Veterans Administration Medical Center
Bath, NY

Project: FCA Upgrade Auditorium, Bldg. B92
VAMC Project # 528A6-12-606

ADDENDUM #1

4 June 2013

Attachment #1 – Revised Partial Demolition Plan

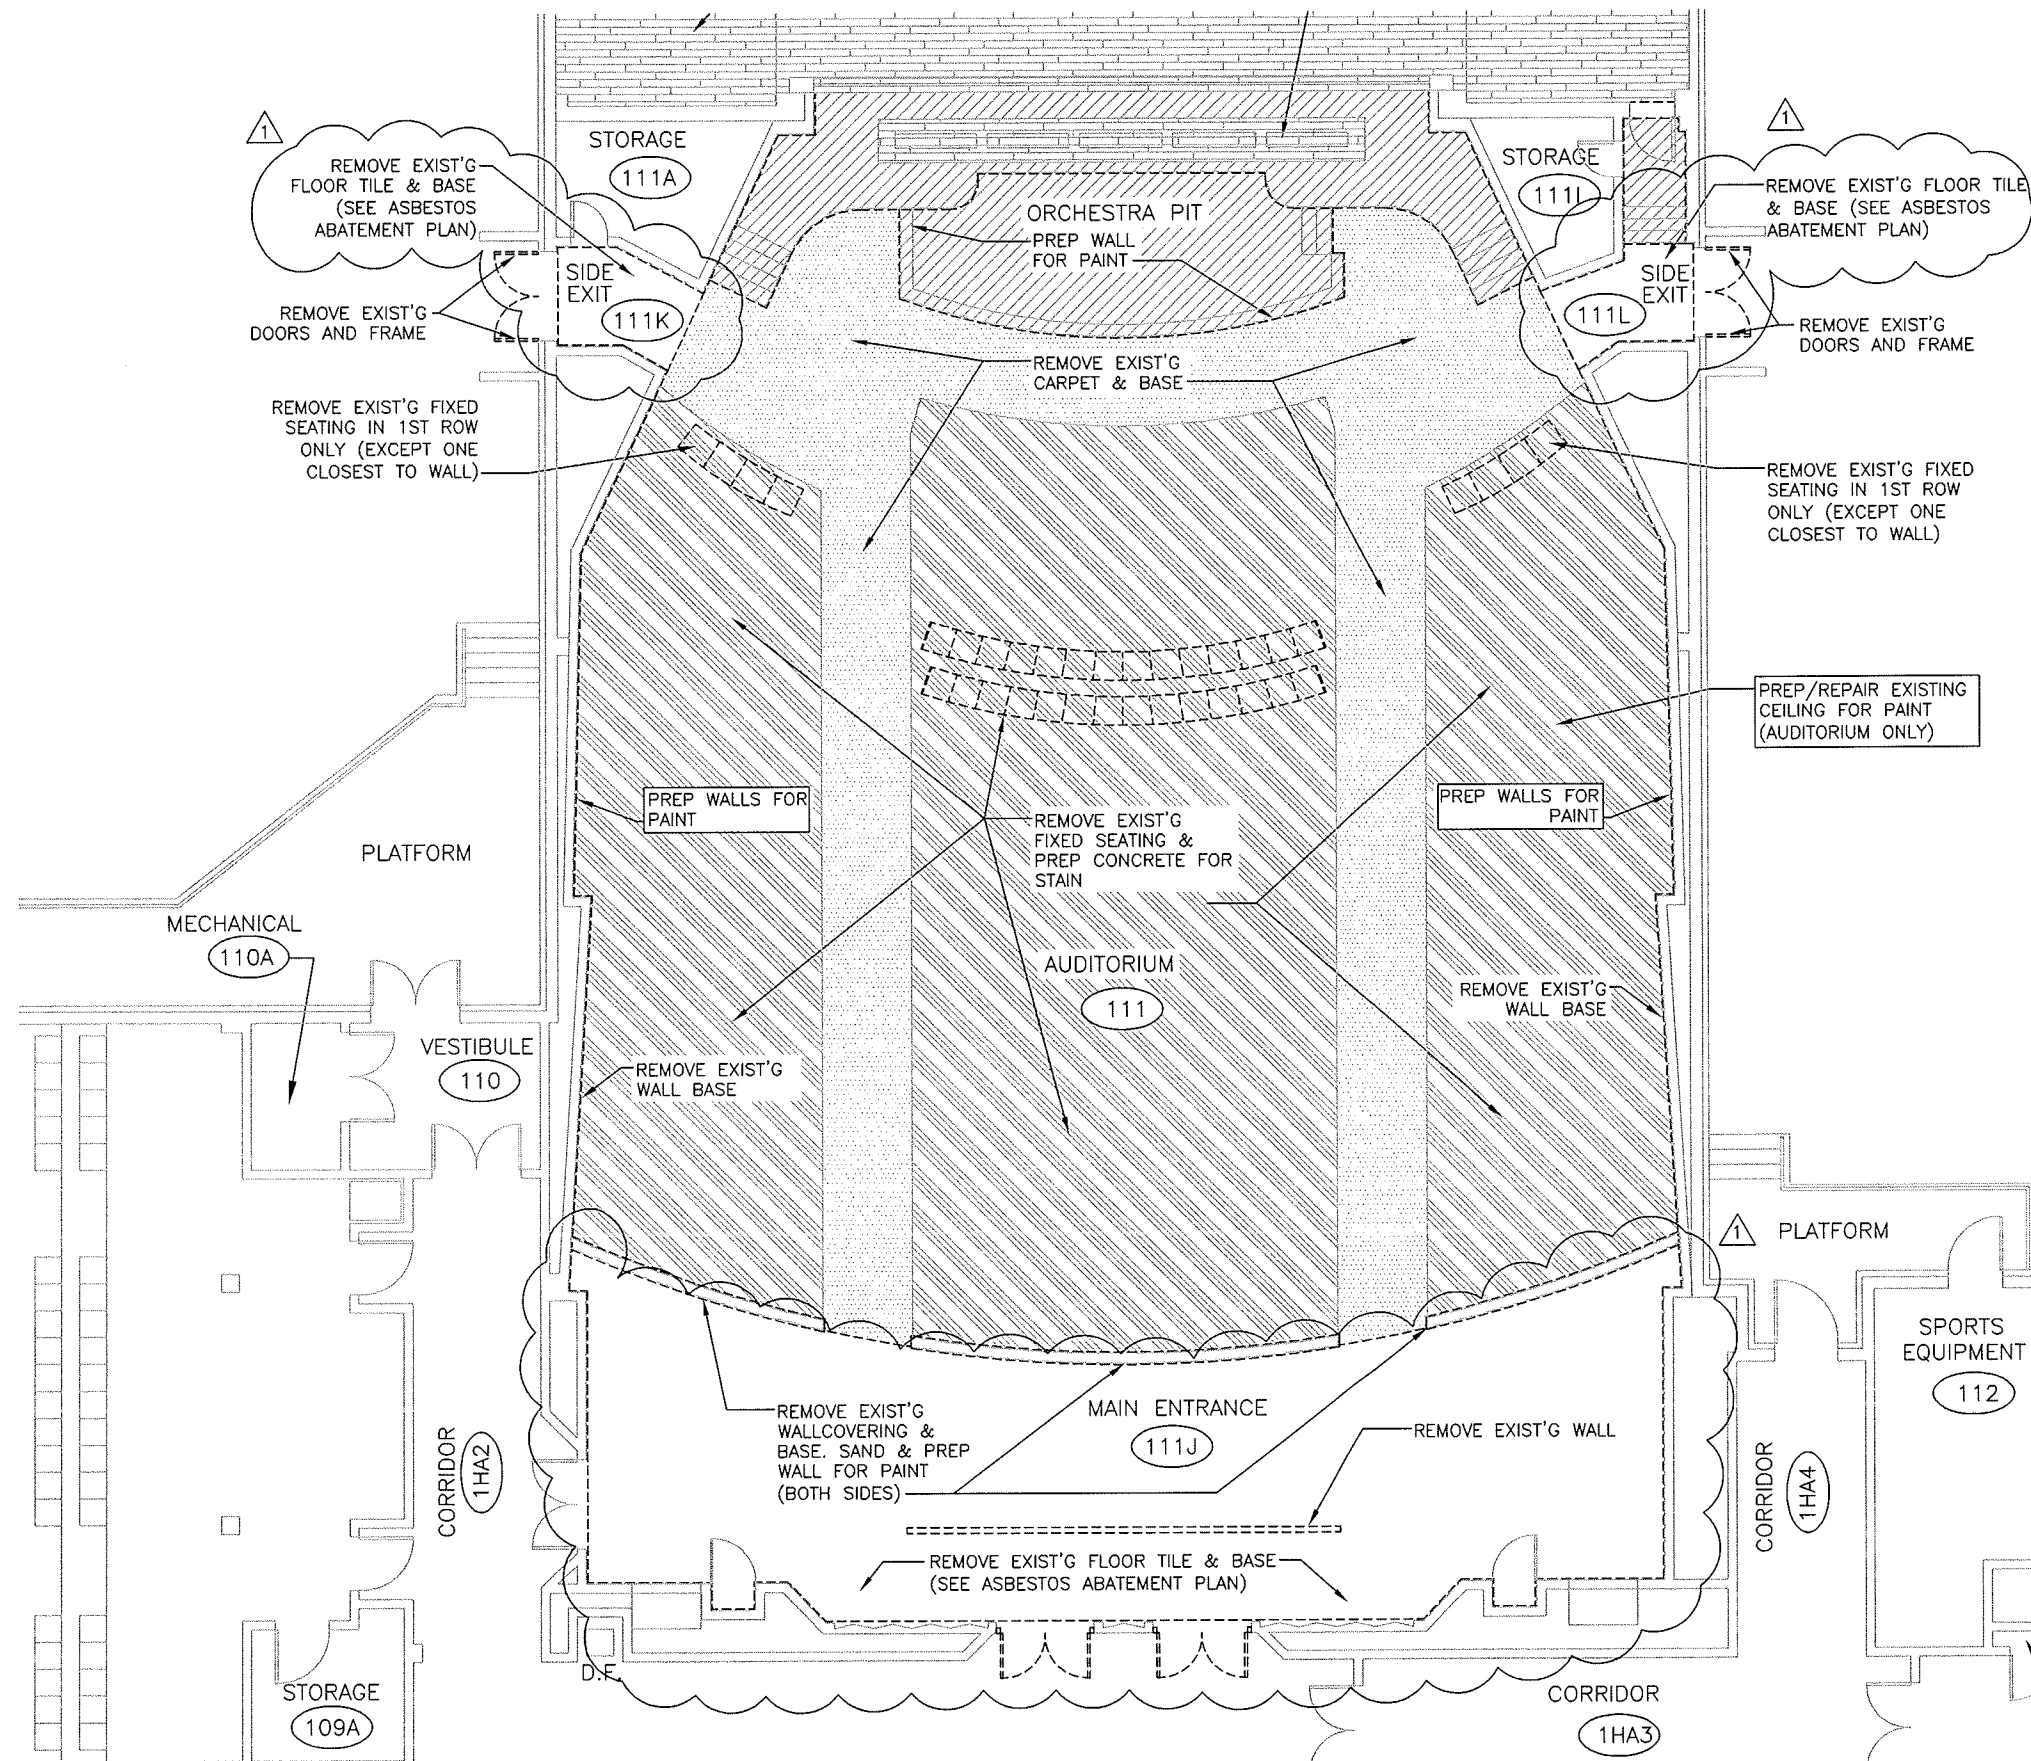
- A. **Drawing A-1, Demolition Plan & Notes**, 1/1-A1 First Floor Demolition Plan, Add room names and numbers; Main Entrance 111J and Side Exits 111K and 111L, see attachment #1 for reference.

- B. **Drawing A-1, Demolition Plan & Notes**, 1/1-A1 First Floor Demolition Plan, Main Entrance 111J and Side Exits 111K and 111L areas to be added to abatement plan for removal of existing tile and base (see asbestos abatement plan), see attachment #1 for reference.

1st Flr. Asbestos Abatement Plan
 1 AA-1 NTS

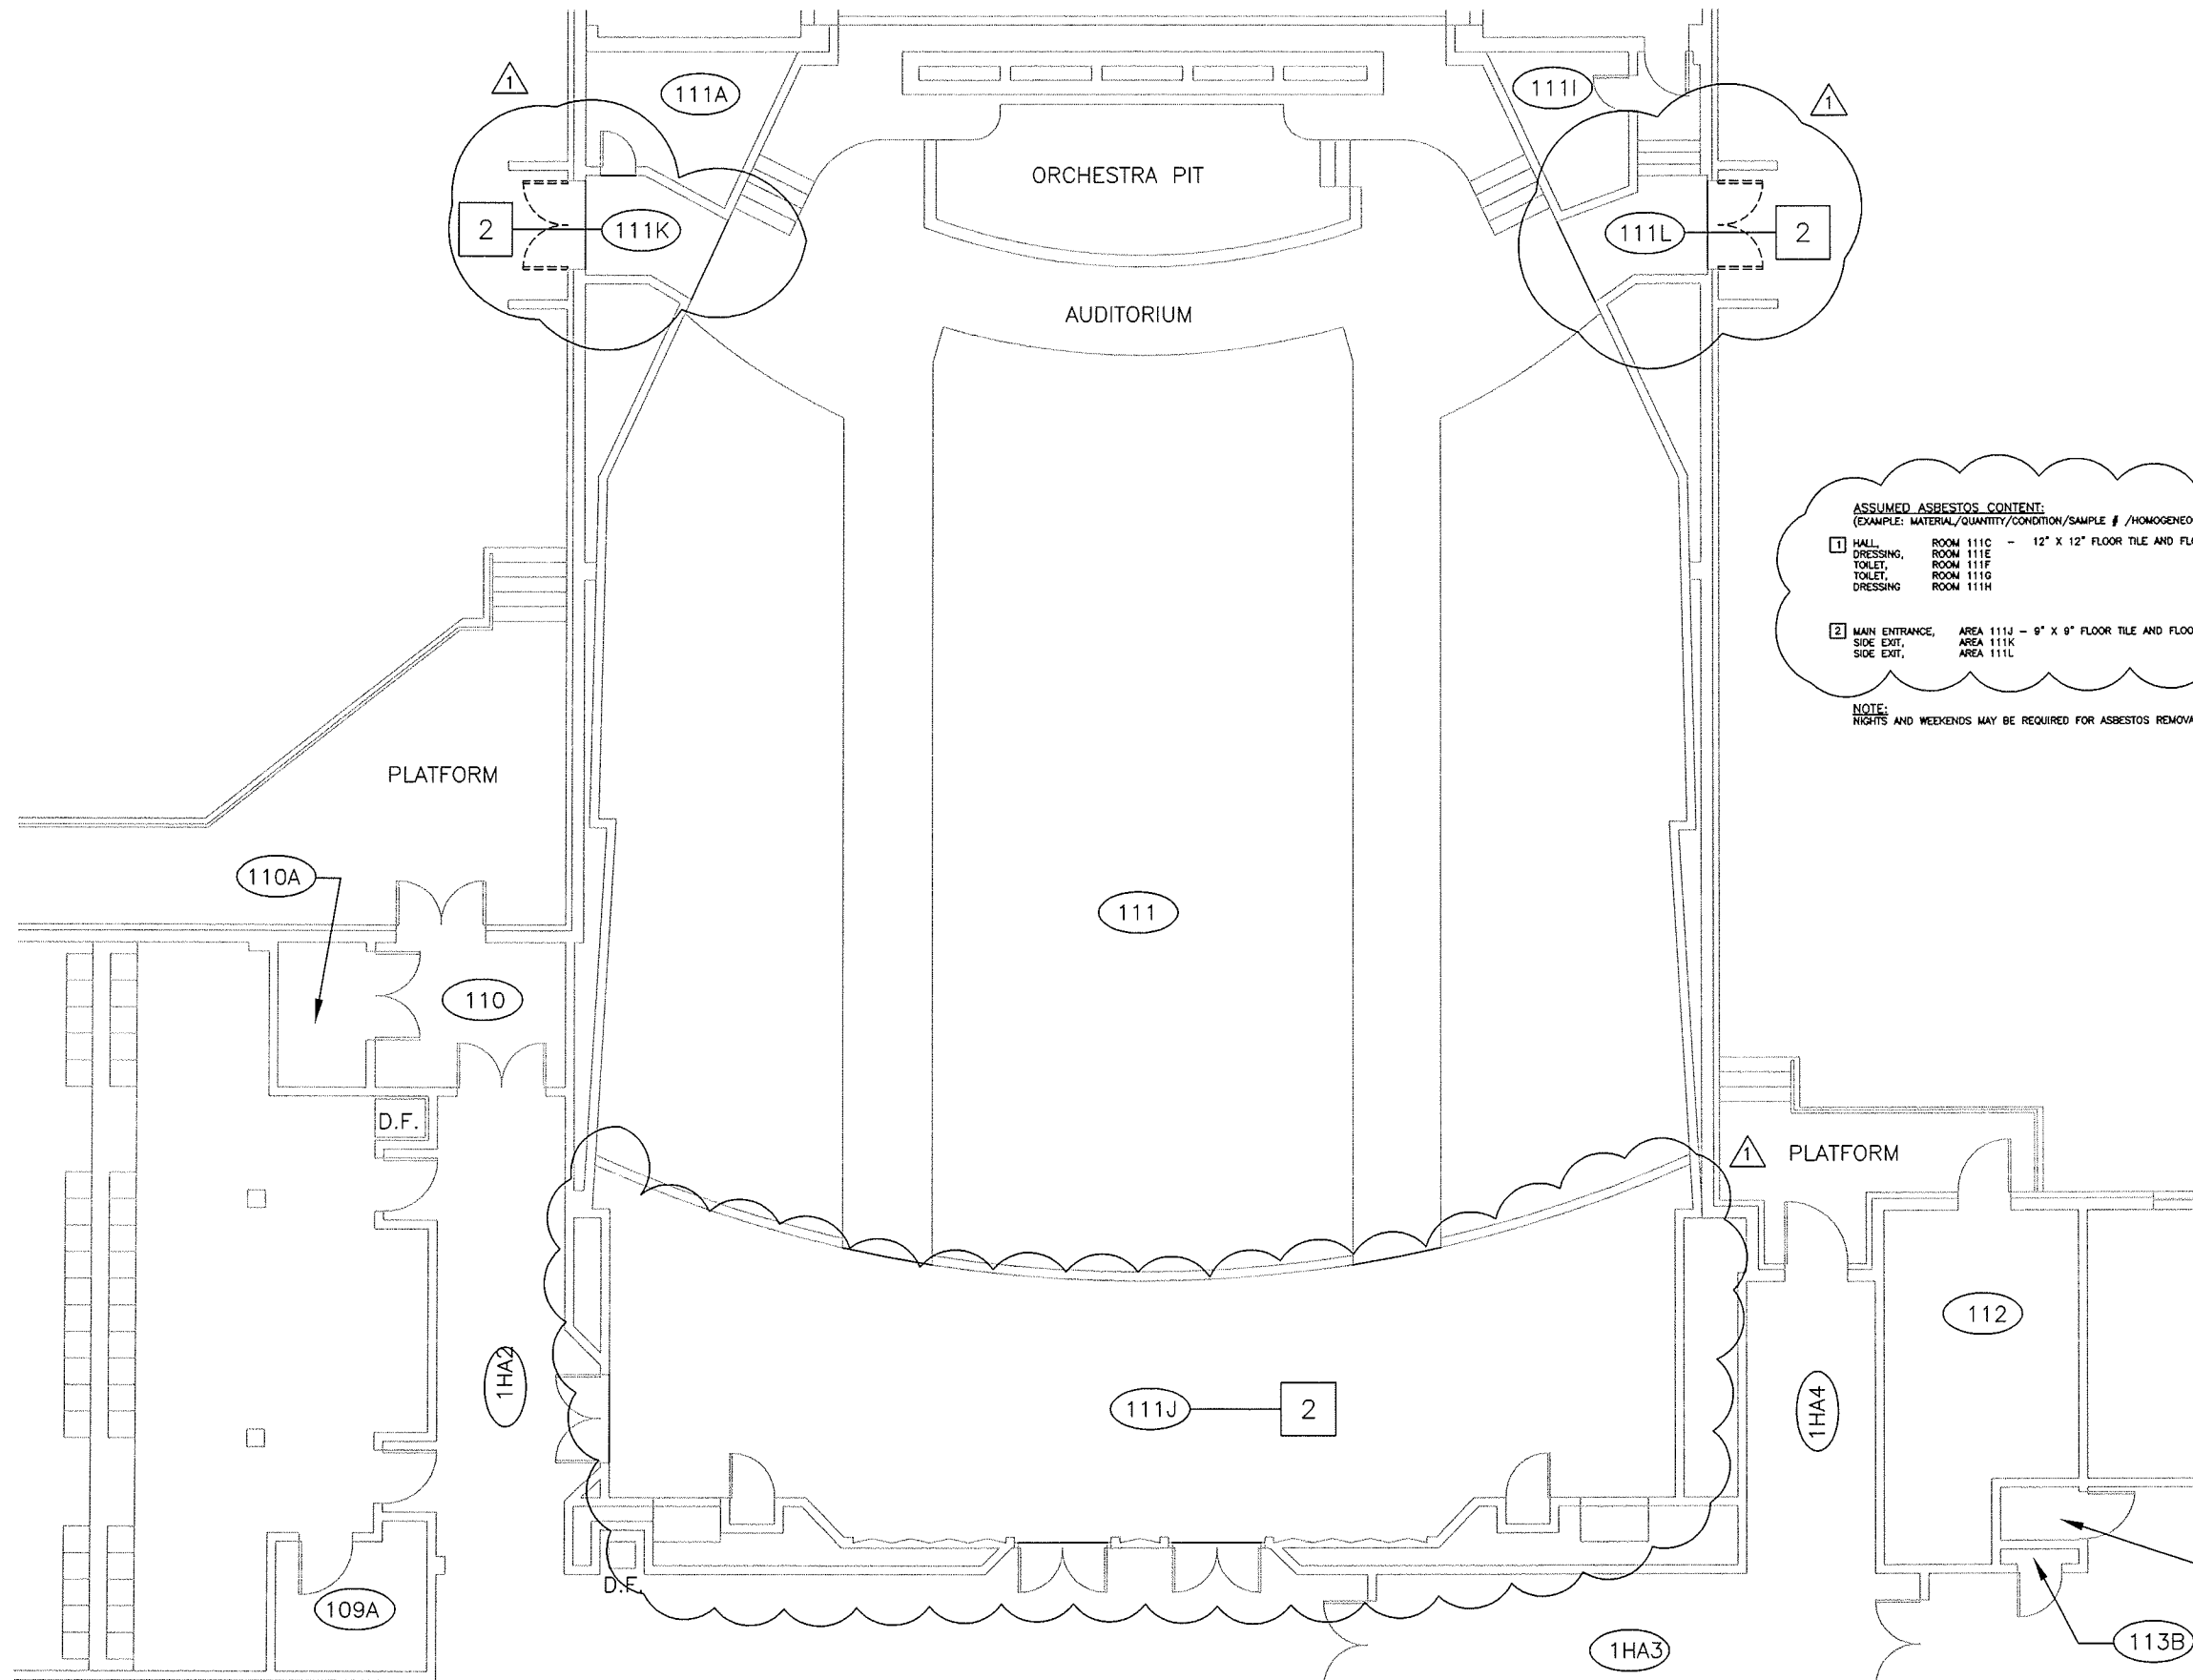
- C. **Drawing ACM-101, Asbestos Abatement Plan**, 1/AA, Assumed Asbestos Content, add note #2, "9" x 9" floor tile and floor tile mastic, see attachment #2 for reference.

- D. **Drawing ACM-101, Asbestos Abatement Plan**, add room names and numbers Main Entrance 111J, Side Exit 111K and 111L, see attachment #2 for reference.

- E. **Drawing ACM-101, Asbestos Abatement Plan**, add note indicator 1 to Main Entrance 111J and Side Exits 111K and 111L, see attachment #2 for reference.

1 HALL, DRESSING, TOILET, TOILET, DRESSING	ROOM 111C - 12" X 12" FLOOR TILE AND FLOOR TILE MASTIC ROOM 111E ROOM 111F ROOM 111G ROOM 111H
2 MAIN ENTRANCE, SIDE EXIT, SIDE EXIT,	AREA 111J - 9" X 9" FLOOR TILE AND FLOOR TILE MASTIC AREA 111K AREA 111L
